In the Matter of)	
)	
GEORGIA INSTITUTE OF TECHNOLOGY)	Docket No. 50-160-Ren
)	
(Georgia Tech Research Reactor))	
)	
(Renewal of License No. R-97))

NRC STAFF'S RESPONSE TO LICENSING BOARD'S
MEMORANDUM AND ORDER OF SEPTEMBER 26, 1995
CONCERNING CONTENTION 9 (MANAGEMENT)

Subject: Facility License No. R-97. Docket No. 50-160
Application for Amendment of Technical Specifications

Figure 6.1 Georgia Tech Organization for Management and Operation of the GTRR.

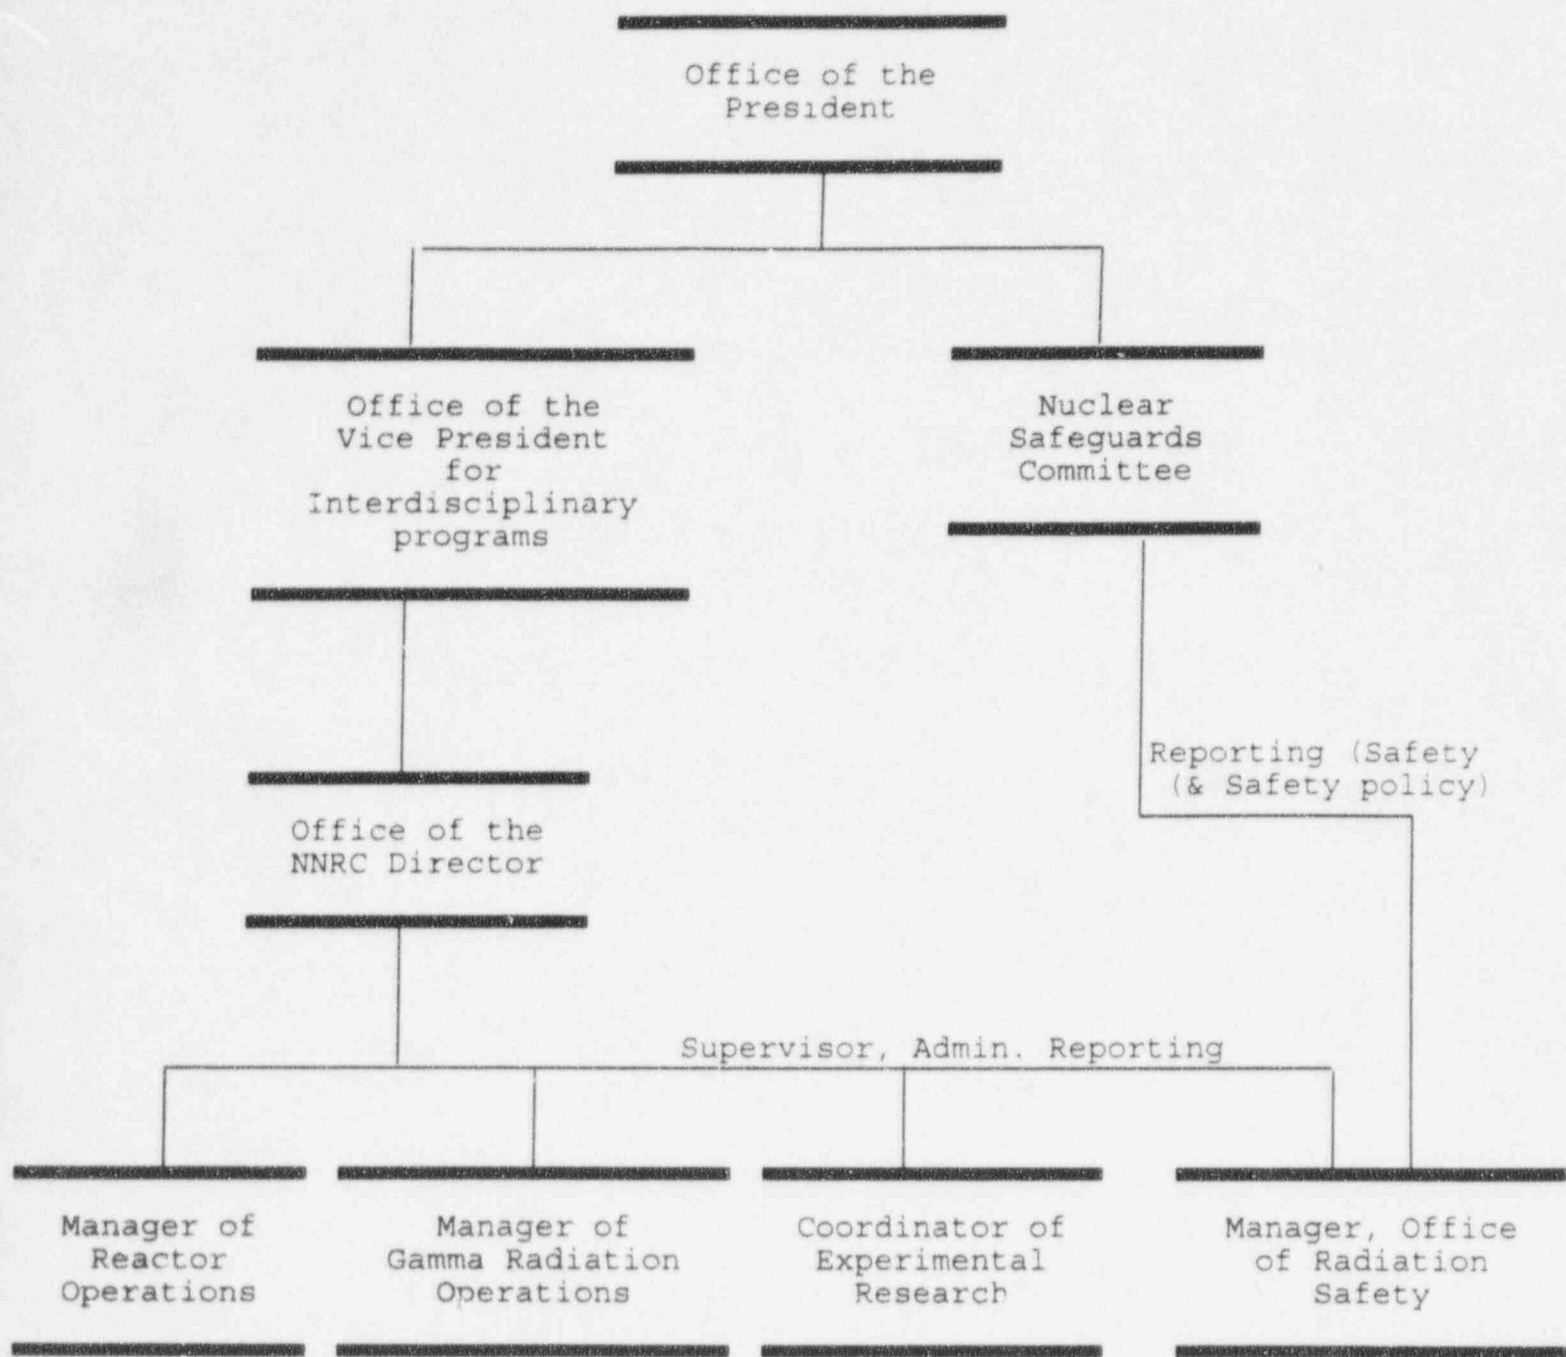
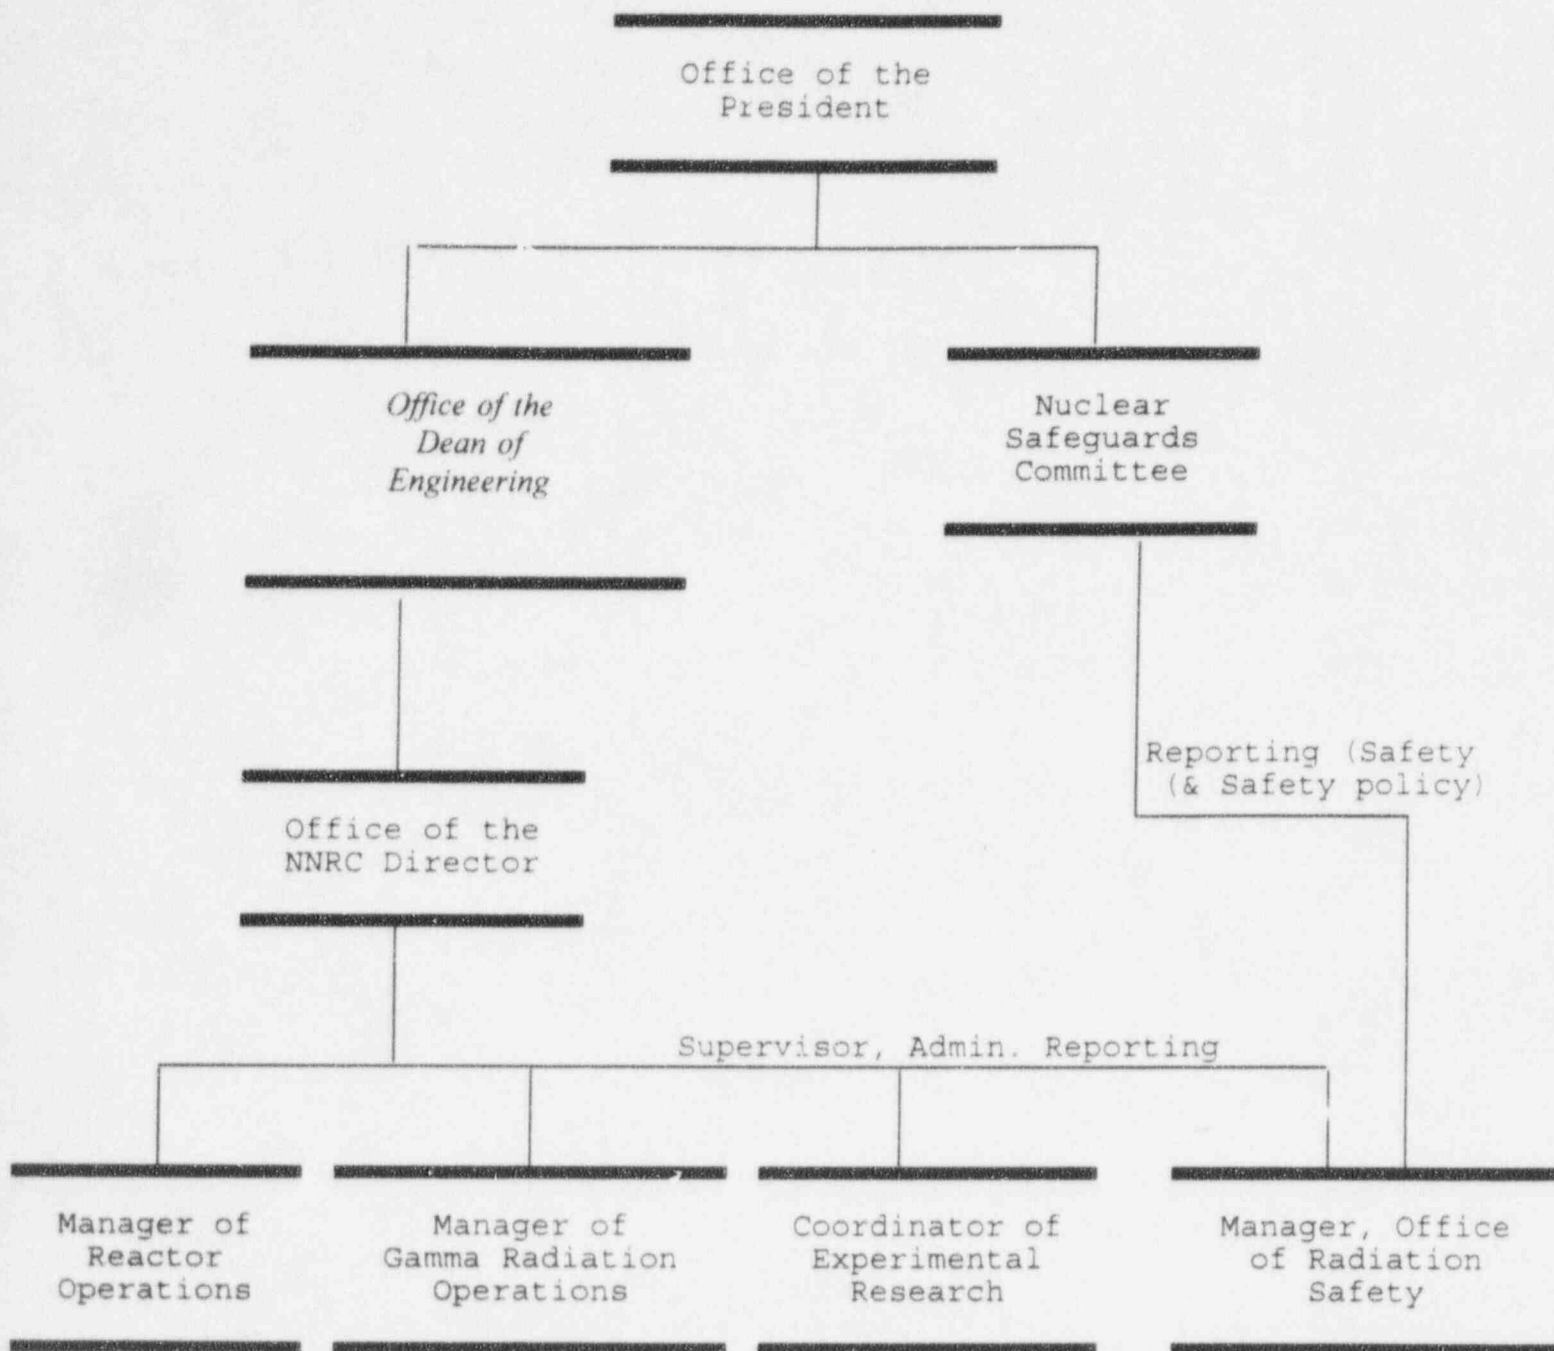
The scope of the Technical Specifications change is limited to Section 6, Administrative Controls. In the current version of the Technical Specifications, the Director of the Neely Nuclear Research Center (NNRC) reports to the Vice President for Interdisciplinary Programs. The position of Vice President for Interdisciplinary Programs is being eliminated. After the planned reorganization, the Director of NNRC will report to the Dean of the College of Engineering, who reports directly to the President of the Institute.

The change in the Organizational Chart, page 39 (T.S.), impacts one other page in the Technical Specifications: page 38. This page is also modified accordingly. The change further impacts page 156 of the Safety Analysis Report (dated April 1994 and revised January 10, 1995). This page is also modified accordingly.

Figure 6.1 Georgia Tech Organization for Management and Operation of the GTRR. (Amendment 11).
